SEWER COVER SHEET FOR GERMAINE KORUM CENTER

CITY OF PUYALLUP ENGINEERING DIVISION
REVIEWED BY: Mark Higginson
SUBMITTED BY:
DATE: 11/18/2021
FOR FURTHER REVIEW
FOR CITY SIGNATURE
RETURN THIS COPY
SUBMIT

SANITARY SEWER AND STORM DRAIN MODIFICATION PLAN

SANITARY SEWER MODIFICATION PLAN

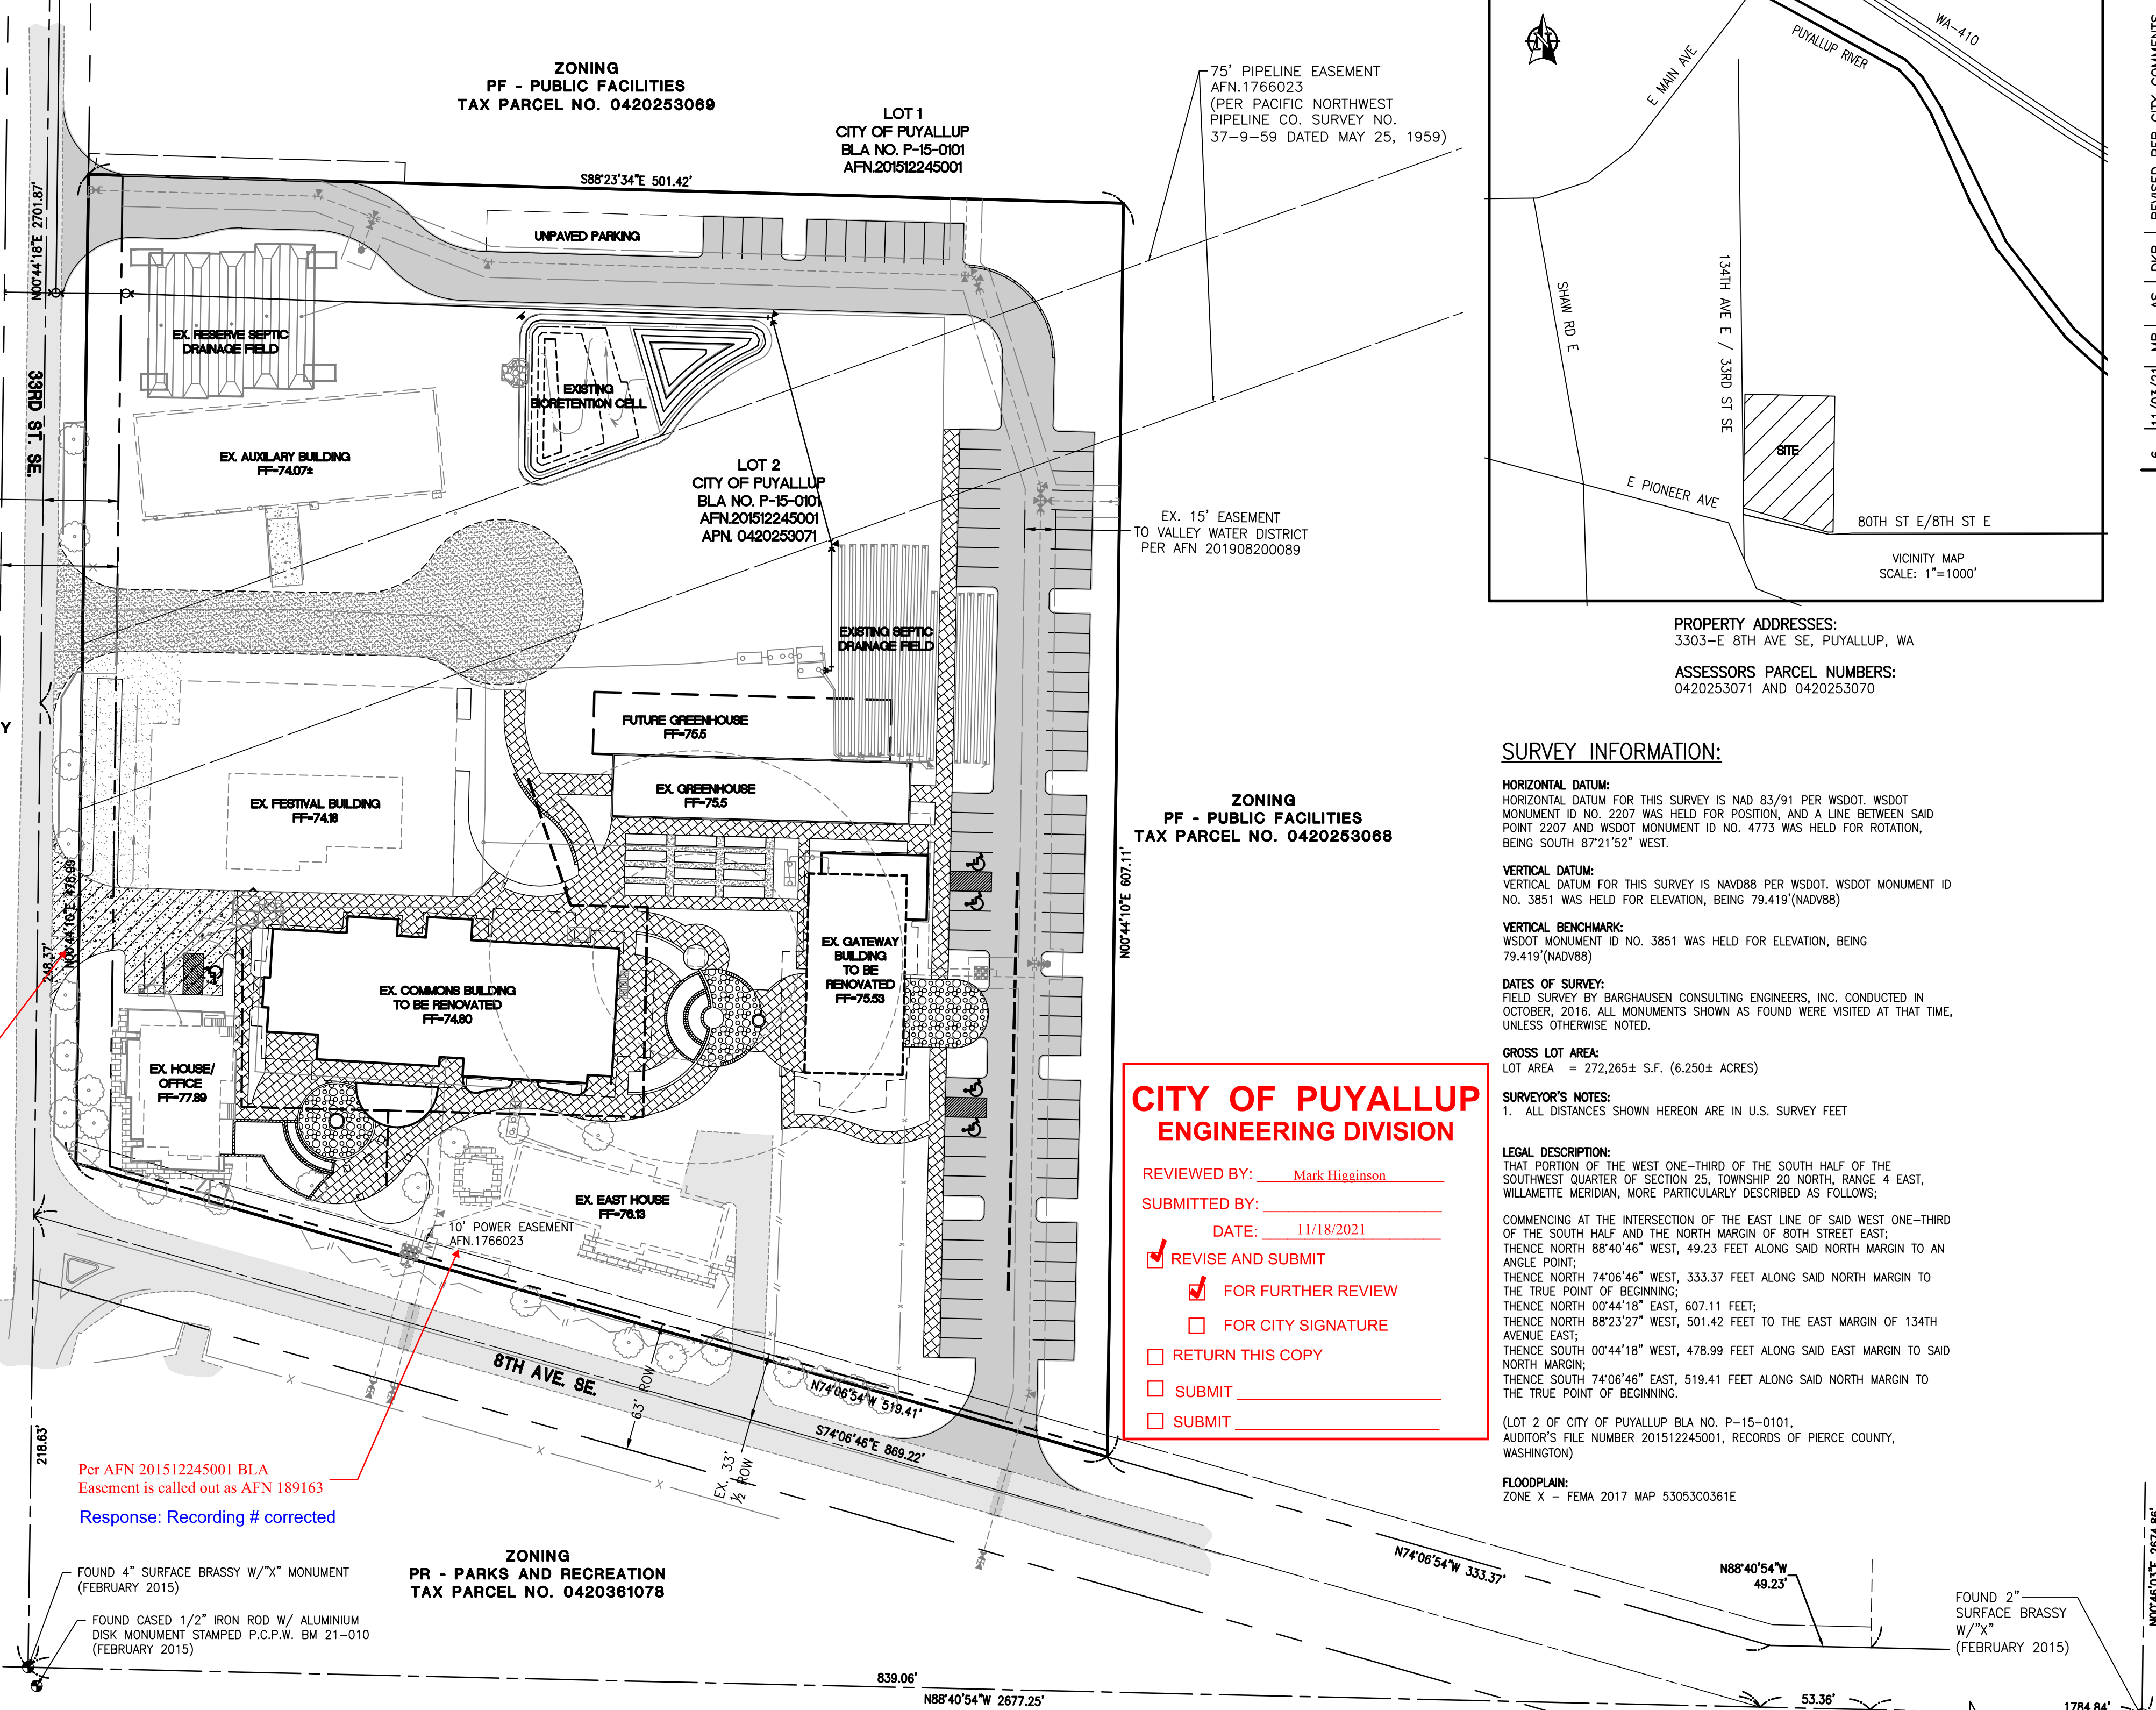
Per AFN 202005280613 Dedication 1/2 ROW should be 36.5 ft.

Per AFN 201512245001 BLA Bearing is called out as N0044°18'E

Per AFN 201512245001 BLA Easement is called out as AFN 189163

Response: Dimension corrected

Response: Bearing corrected

Response: Recording # corrected

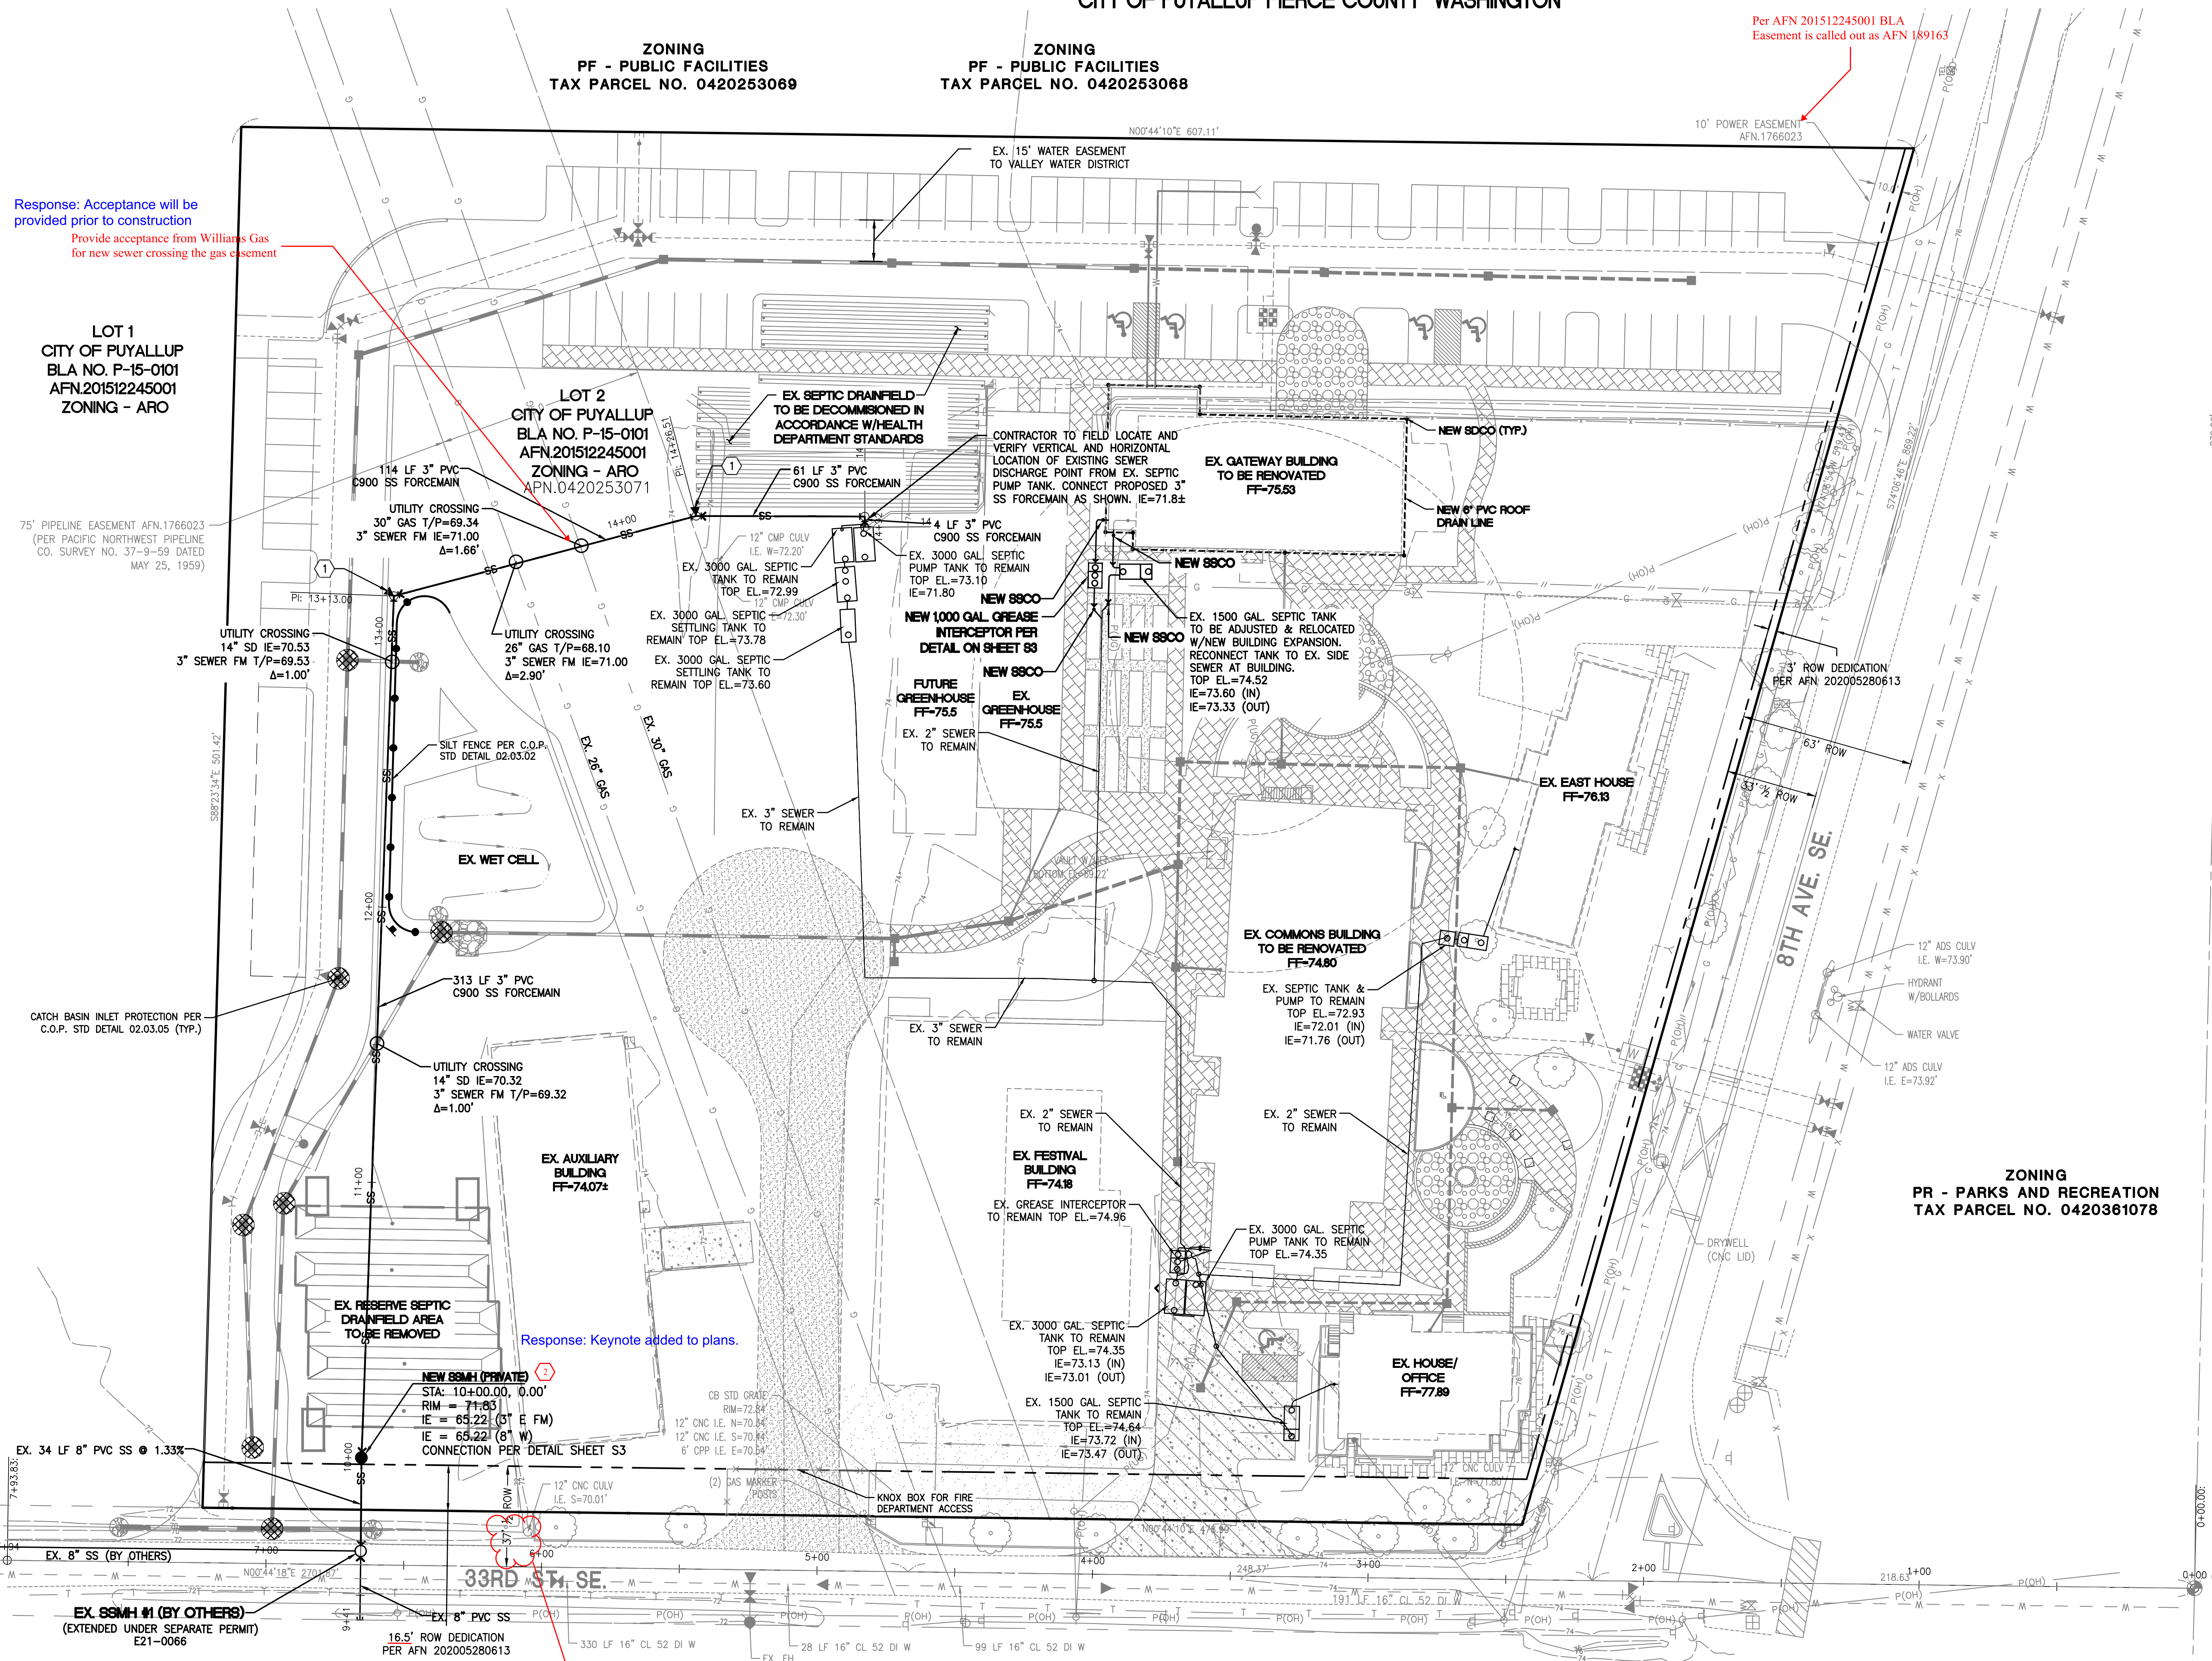
Per AFN 201512245001 BLA Easement is called out as AFN 189163

Provide acceptance from Williams Gas for new sewer crossing the gas easement

- CONTRACTOR TO INSTALL A CLEANOUT UPSTREAM OF BEND AS A FLUSHING POINT.
Callout for Thrust Block? (symbol is shown on plan, but no reference)
- Prior to operation of the new onsite sewer system, a separate Utility Connection Permit shall be obtained from the City.
Response: Keynotes updated.

Response: Easement correctly called out as AFN. 189163.

Response: Acceptance will be provided prior to construction

FORCE MAIN TO EXISTING MANHOLE CONNECTION

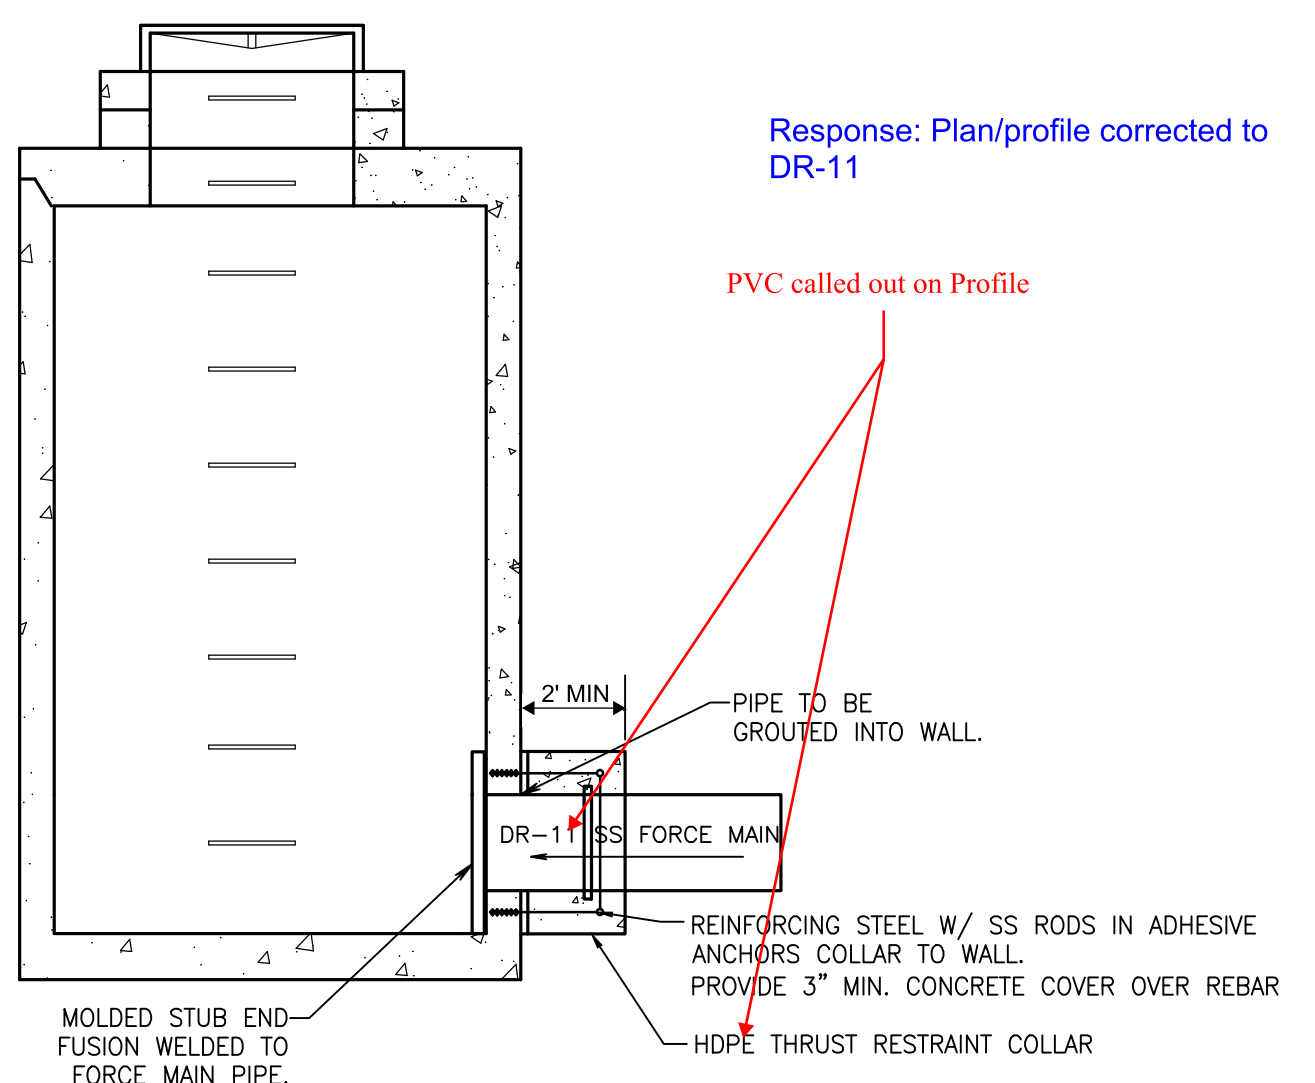
IE 65.33? ...allows channel to drain after pump shutoff
Response: IE changed to 65.22.

CONTRACTOR TO FIELD LOCATE AND VERIFY VERTICAL AND HORIZONTAL LOCATION OF EXISTING SEWER DISCHARGE POINT FROM EX. SEPTIC PUMP TANK, CONNECT PROPOSED 3" SS FORCEMAIN AS SHOWN. IE=71.8±
Provide system information including:
-Duplex station req'd in case of primary pump failure (see Orange Book)
-Peak flow calculations
-head calculations and FM sizing
-system curves/analysis for pump selection-
-pump identification
-pump cycle and run times
-On/Off/Alarm levels and active storage volume
-Identify backup power source and location on the project site
-If portable backup power, show emergency storage capacity of the existing septic tank based on peak inflows (min. 24-hrs of storage is preferred in case of failure)
-Location of system alarm panel/signal

PVC called out on Profile

Response: Plan/profile corrected to DR-11
